## CORRECTION

### WIRING DIAGRAM OF AN AMPLIFIER FOR DIFFERENTIAL THERMAL ANALYSIS

CARL W. BECK, *University of New Mexico, Albuquerque, New Mexico.*

FIG. 2. Schematic diagram of amplifier.

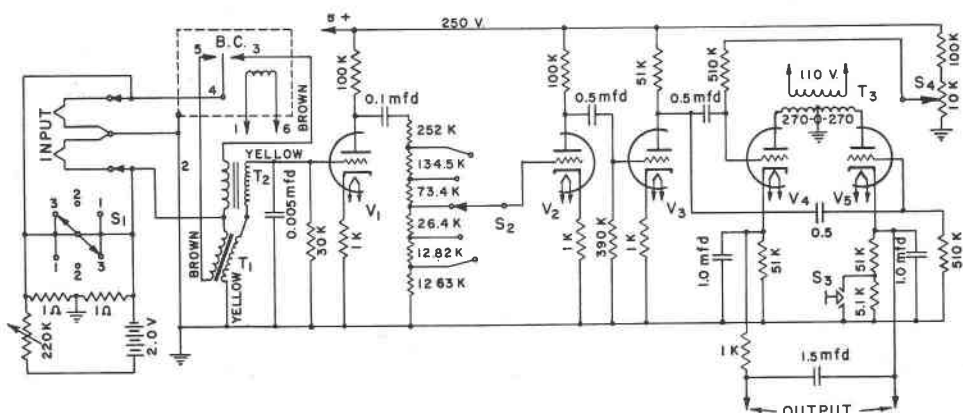
Attention has been called to two drafting errors in Figure 2, p. 509, *Am. Mineral.*, Vol. 35. (1) The wire coming from  $S_4$  should not connect to the 250V line—if the  $S_4$  were turned down to the ground end it would short out the power supply. (2) The grid on tube  $V_5$  is grounded—this is corrected by adding a 510K grid leak. Both of these errors have been corrected on the wiring diagram below.
